**PLANNED UNIT DEVELOPMENT
& SUBDIVISION STAFF REPORT****Date: November 17, 2016****DEVELOPMENT NAME**

Autonation Ford of Mobile

Autonation Ford of Mobile Subdivision

CONTEMPLATED USEPlanned Unit Development Approval to amend a
previously approved Planned Unit Development to allow
multiple buildings on a single building site along with
shared access between multiple building sites; and
Subdivision approval to create three legal lots of record.**TIME SCHEDULE
FOR DEVELOPMENT**

SITE PLAN

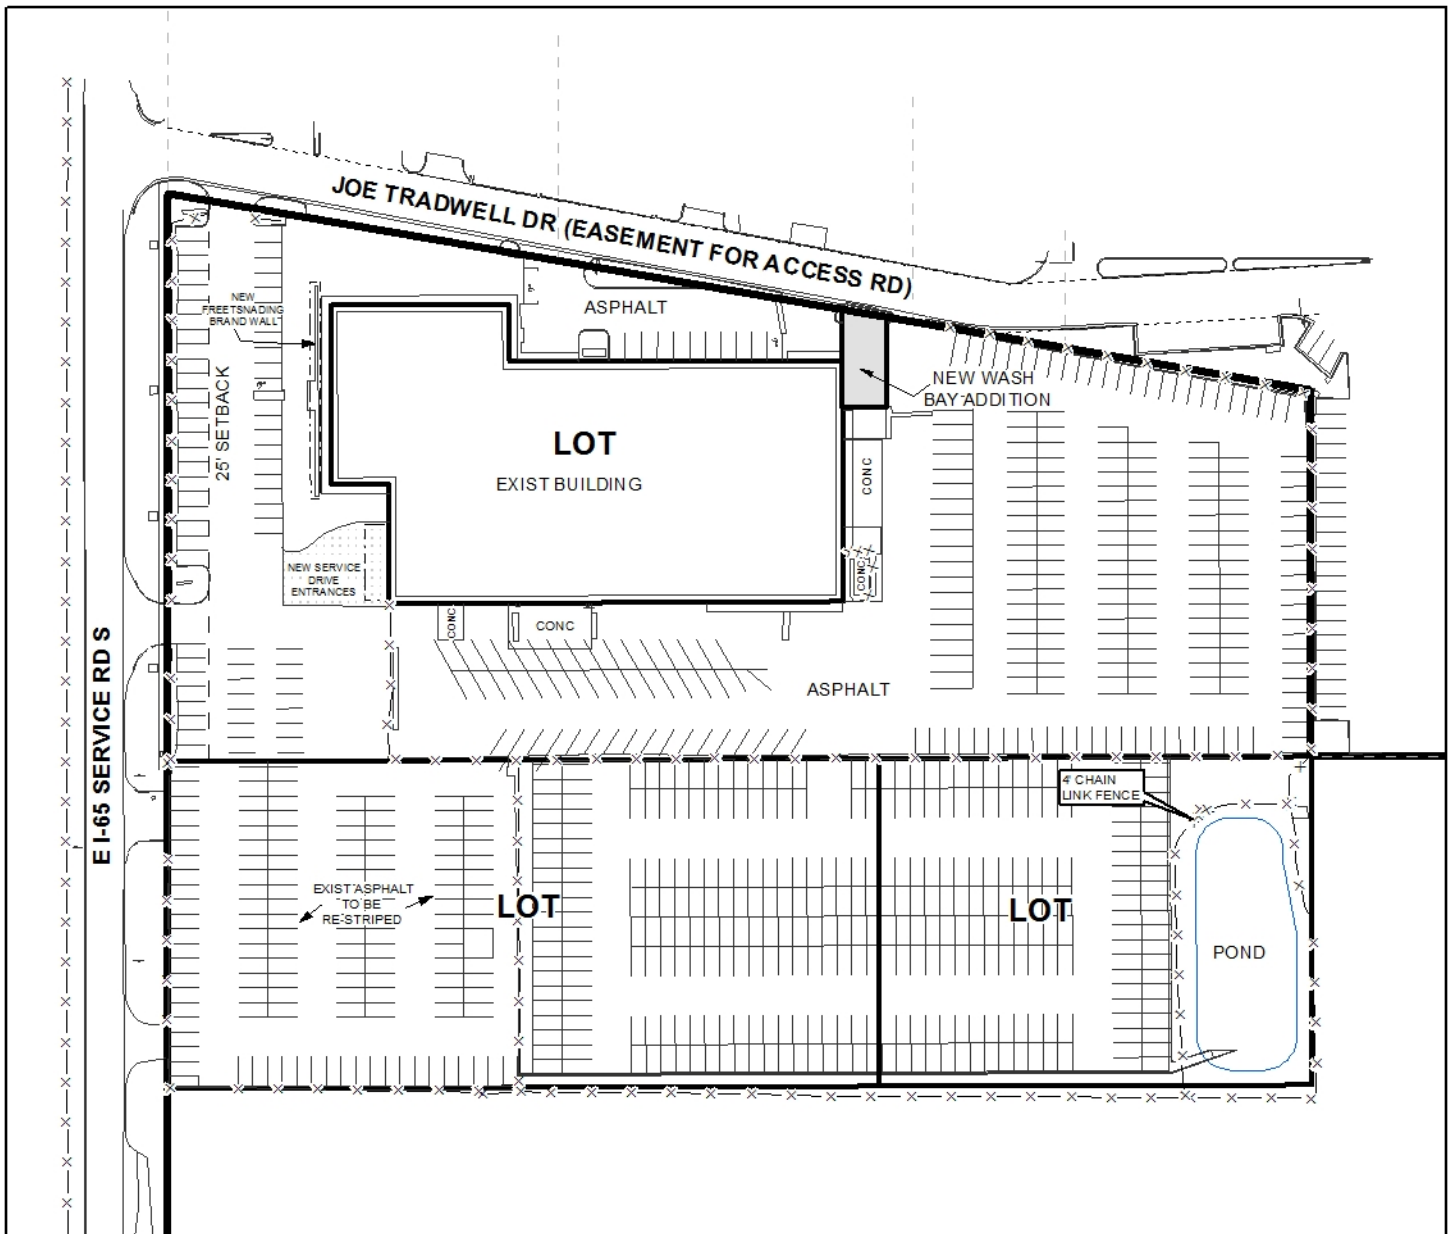
Planned Unit Development: PUD Site Plan was not labeled. Two different plans were included, one with and one without the parking lot to the south.

Regarding the PUD request, the applicant proposes to extend development of the Autonation Ford of Mobile site to the smaller of the two illustrated lots to increase the storage capacity of new vehicle inventory. There are 450 parking spaces illustrated on the aforementioned lot, and are reserved for vehicle inventory according to a table illustrated on the site plan. A portion of the proposed inventory area shows parking spaces stacked for four vehicles with no access aisles between them. Such configuration of vehicle inventory is common, but these spaces should be clearly indicated on the site plan as being reserved exclusively for inventory and not for customer parking. Furthermore, the area proposed for inventory storage is depicted as being completely enclosed with a chain-link fence with no access aisles. If approved, the site plan should be revised to indicate a gate and access aisles.

With regards to the existing Automation Ford of Mobile development, a separate site plan illustrates the existing site improvements, to include: a 48,010 s.f. building; an approximately 551 s.f. shed; 415 delineated parking spaces; and existing signage. Proposed site improvements include: the addition of an approximately 1,134 s.f. wash bay to the rear of the existing building; new concrete paving, where required; new asphalt paving to facilitate water drainage from the proposed wash bay; a new gate and fence to restrict access to the site along its easternmost, existing curb cut; and additional signage.

While parking is illustrated on the site plan, it is unclear which spaces are reserved for the parking of inventory; therefore, Staff cannot determine if the site is equipped with adequate amounts of off-street parking for customers and employees of the development. As a result, Staff also cannot determine compliance with parking lot lighting, parking stall requirements regarding stall dimensions, or if curbing or wheel stops are provided where customer and employee vehicles may extend beyond the parking facility; and, Staff cannot determine compliance with ADA regulations regarding required amounts of accessible parking spaces and their required dimensions. As such, the site plan should be revised to clarify this information and illustrate compliance with off-street parking requirements of Section 64-6.A. of the Zoning Ordinance.

Regarding existing and proposed structures, while they will not impact the site with respect to maximum building site coverage in a B-3, Community Business District, their dimensions should be clearly illustrated on a revised site plan.

The proposed wash bay in the rear of the property does not appear to meet setback requirements of the Zoning Ordinance regarding structures in a B-3 district subject to previous PUD approval, or screening or drainage requirements of the Zoning Ordinance regarding car wash facilities. The proposed structure must be either 0' or 5' from the property line, but is illustrated as being approximately 3' from the property line. It should be noted, however, that a proposed island facilitating an existing curb cut will prohibit the structure from being constructed to the property line; and, while the structure could be reduced in width by approximately 2' to accommodate a 5' setback, approval of the proposed setback may be appropriate since it would effectively facilitate maneuverability from the rear of the site to the front of the site by restricting one-way traffic circulation at a location not adequate for two-way traffic due to the proposed island. Also, while the proposed structure is enclosed on at least two sides, vehicles must be screened from view with a 3'-5' tall evergreen hedge, landscaped berm, or privacy fence along the side(s) of the property from which the wash bay will be visible; and, all water run-off from washing activity must drain into the proper sewer system through an oil separator. Revision of the site plan to illustrate compliance with Section 64-12 of the Zoning Ordinance regarding car wash facilities should be required.

It should be noted that it is unclear if all existing and proposed fencing on the site does, or will, comply with the Zoning Ordinance. Also, in a pre-development meeting with Staff, the applicant expressed a desire to erect barbed-wire fencing on the site; however, no such fencing is illustrated. A revised site plan should indicate that existing and proposed fencing complies with Section 64-4.D.6. of the Zoning Ordinance; and, if any fences composed of barbed wired are proposed, that they comply with Section 64-4.D.6.b., specifically, of the Zoning Ordinance.

Signage proposed on the site plan for Autonation Ford of Mobile appears to exceed maximum allowable signage requirements of the Zoning Ordinance. While the Planning Commission may consider such additional signage with respect to the PUD, Staff has not been provided specific information regarding the signs themselves to illustrate compliance with sign dimension and location requirements; and, as such, should be illustrated in a sign package that will facilitate the review of such information.

Landscaping is not proposed on the site plan, but since the total gross floor area of existing and proposed structures on the site is neither increasing nor decreasing by fifty (50) percent, full compliance with landscaping is not required at this time. However, it should be noted that the Planning Commission typically requests frontage trees for Planned Unit Developments, which should be illustrated on a revised site plan along with any existing trees and landscaping, in compliance with Section 64-4.E.3. of the Zoning Ordinance.

A dumpster is not depicted on the site plan and one is not clearly visible in recent aerial photos. Any dumpster placed on the property must be in compliance with the current enclosure and sanitary sewer connection requirements of Section 64-4.D.9. of the Zoning Ordinance and must be illustrated on a revised site plan(s); or, placement of a note on the revised site plan stating that curbside pickup will be utilized will be acceptable.

It should be noted that separate site plans were submitted to Staff for review, neither of which illustrate the entire development across the existing site and the two proposed lots to which the applicant proposes shared access. As such, and in considering PUD review is site-plan specific and takes into consideration the entire development, proposed or otherwise, the applicant should submit a revised site plan inclusive of all three lots.

- 1) submit a full site plan illustrating all existing and proposed site improvements to the entire Planned Unit Development.
